From: [REDACTED]
To: [REDACTED]
CC: [REDACTED]
Sent: 2/24/2021 9:28:40 AM
Subject: RE: O8W-PM [REDACTED] Bucks Creek 1101 Phase 1,2&3 - Pre-Engineering Meeting

Bucks Creek 1101- PM# [REDACTED] Overview Map

Subject: O8W-PM [REDACTED] - Bucks Creek 1101 Phase 1,2&3 - Pre-Engineering Meeting

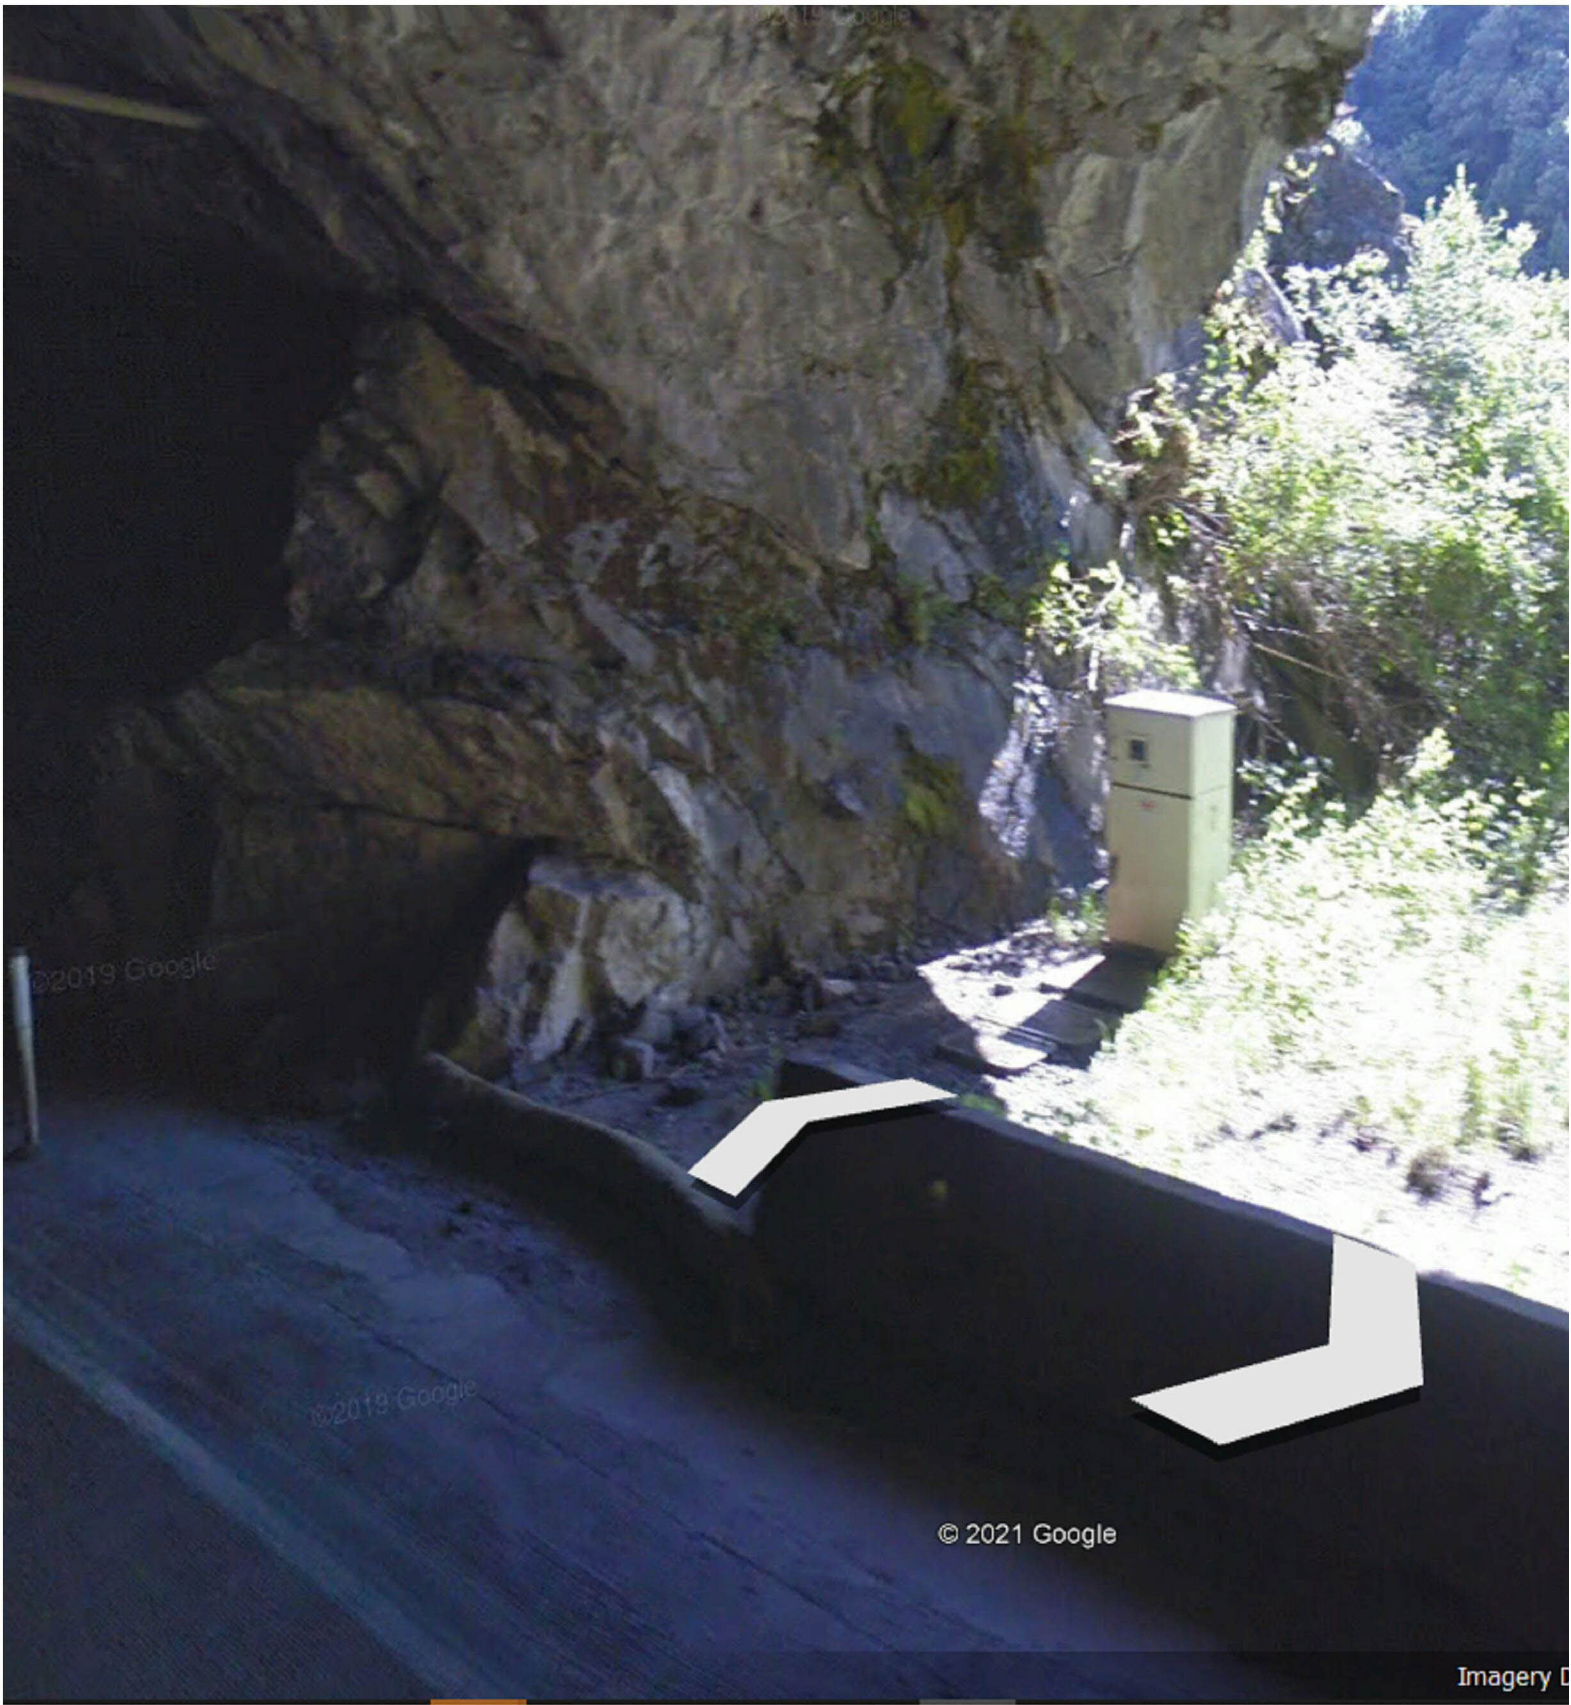
Attached are the 'base-map' limits in a kmz. file. As you will see, we need our base-map to go about ~100' into the tunnel at the south end (see pedestal in picture below....please begin about ~50 beyond this point which is about ~100' beyond the Cresta Dam).

We want to end the base-map at the sign location below which is roughly at MM (Mile Marker) 5.10.

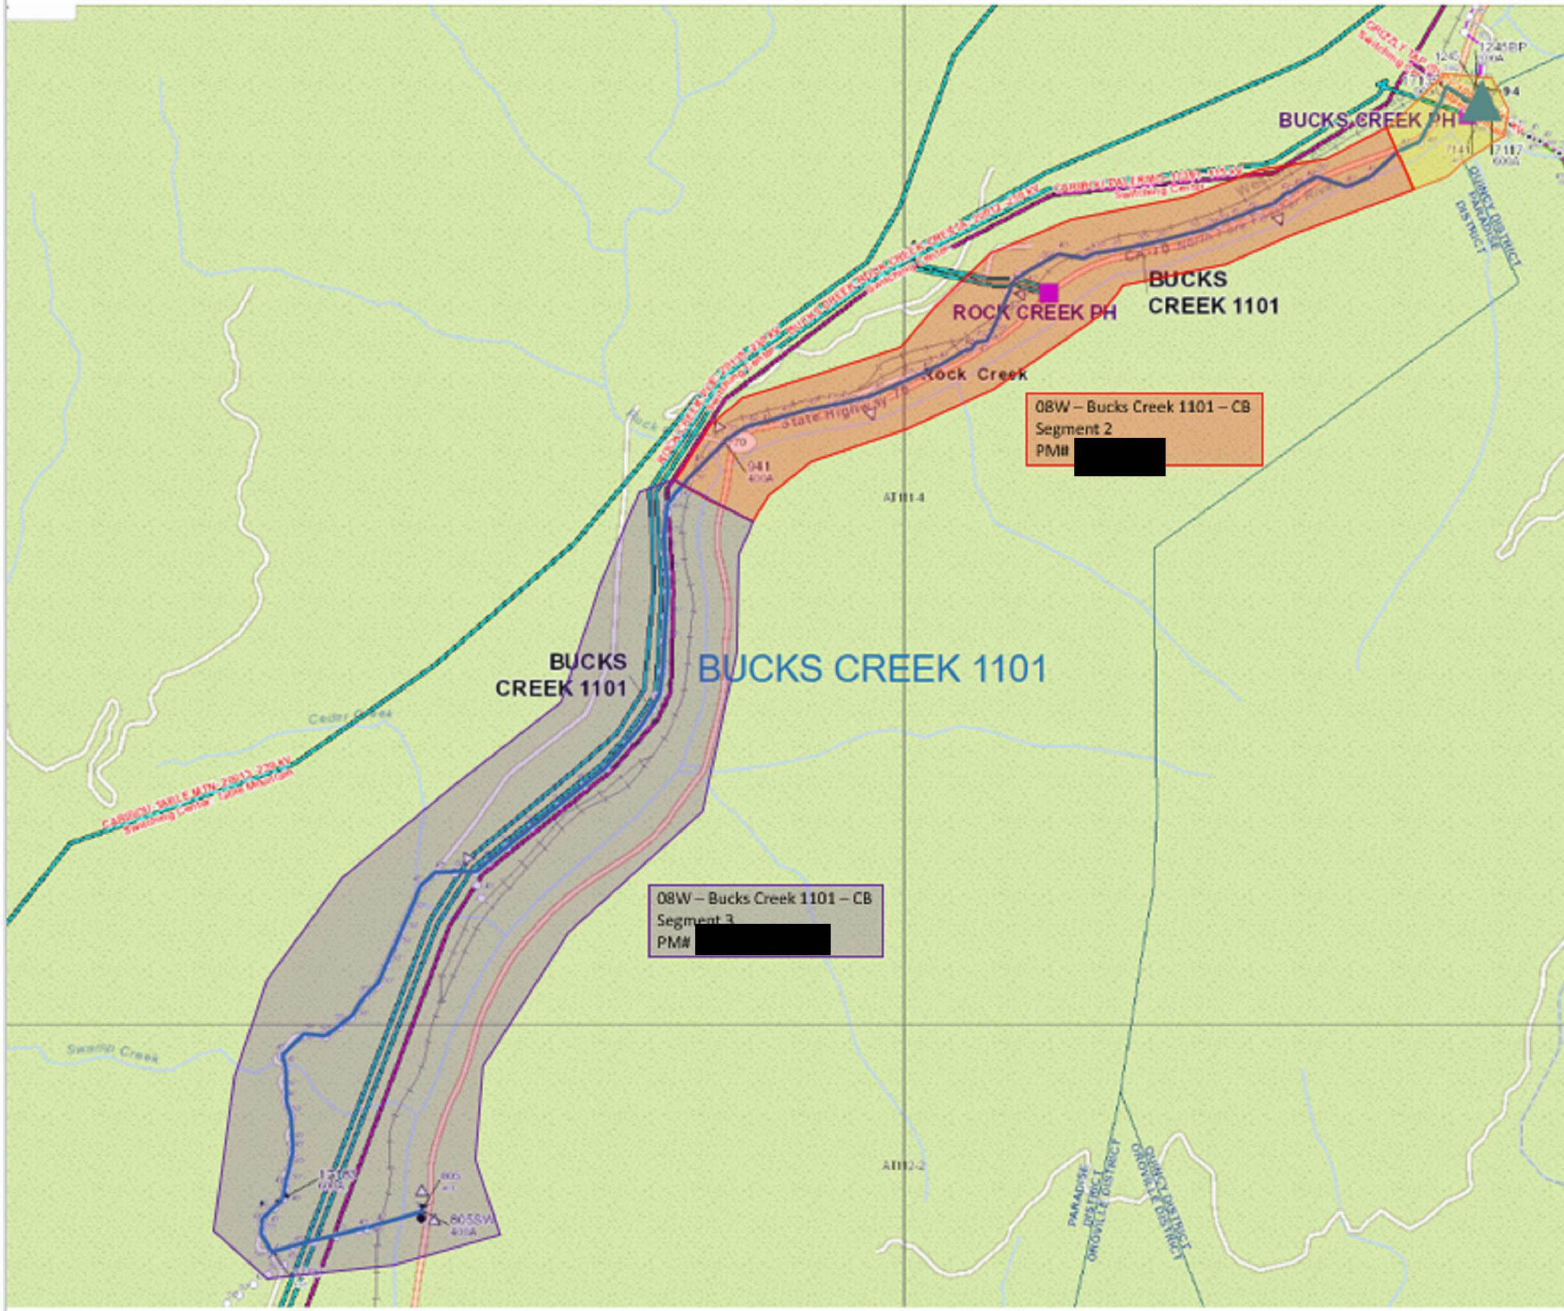
For Bucks Creek there is quite a bit of work surrounding Hwy 70 and we will need a Land Department Base Maps prepared for all 3 Orders. This will delay the EOD dates until these can be developed and provided to the Vendor... We will also need answers to the questions outlined by [REDACTED] below...
